## Stop Use & Product Recall

### 3M™ PROTECTA® Cobra Rope Grab AC202D

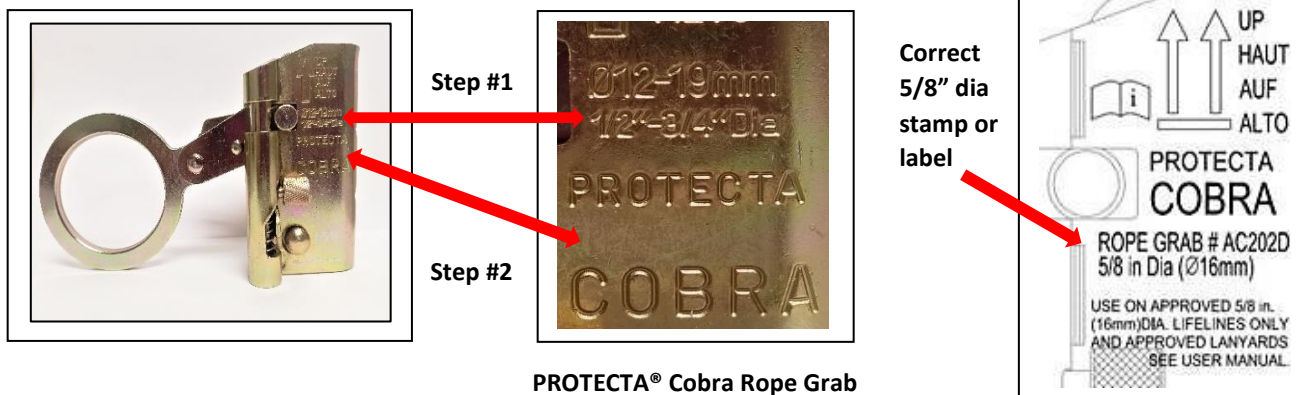
3M Fall Protection has determined that the 3M™ PROTECTA® Cobra Mobile/Manual Rope Grab AC202D is incorrectly stamped for use with 1/2 to 3/4 inch diameter rope on the exterior body of the unit. This Cobra Rope Grab is certified for use **ONLY** with 5/8 inch diameter polyester or polypropylene rope. All marketing information and the Instructions for Use (IFU) for this rope grab correctly identify the size of rope to be used as 5/8 inch polyester/polypropylene rope.

Step 1: Verify the rope diameter is stamped **1/2"—3/4" Dia** on the front side of the unit

Step 2: Verify the rope grab is stamped **PROTECTA COBRA** on the front side of the unit

**Note:** If the unit is stamped 5/8 inch diameter **OR** if the unit has a white label showing 5/8 inch diameter, then the unit is safe to return to normal use (see image on right for correct 5/8" diameter marking).

If the information in Step 1 and Step 2 is stamped onto the side of the rope grab as illustrated above, remove the unit from service immediately. Owners of AC202D Cobra Rope Grabs can choose one of the following options for each affected rope grab they own:

1. A free, new, properly marked replacement AC202D Cobra Rope Grab; or
2. A check for \$100.
